S5000 TECHNICAL BULLETIN

Date	11/10/2021
Topic	Sump Plug Access Hole
Priority	Low - Optional

FIGURE 1. BLOCKED DRAINAGE ACCESS POINT

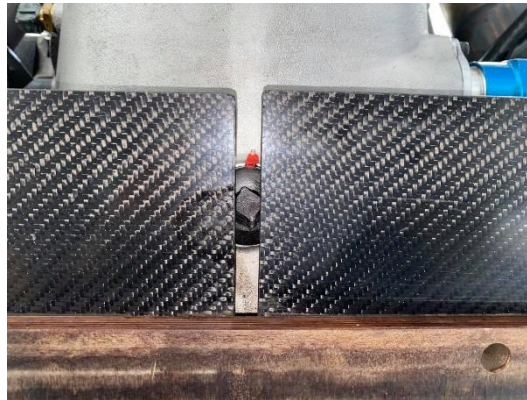
When the sump plug of the gear box needs to be removed for engine oil drainage, the carbon fibre rear floor undertray blocks the drainage point (See Figure 1).

A hole no larger than 50mm diameter will be allowed to be cut out of the undertray to allow access to the sump plug. Simply mark out the circumference of a cylindrical object onto the undertray (Figure 2) and slowly remove the carbon fibre (circular pencil grinder was used in Figure 3).
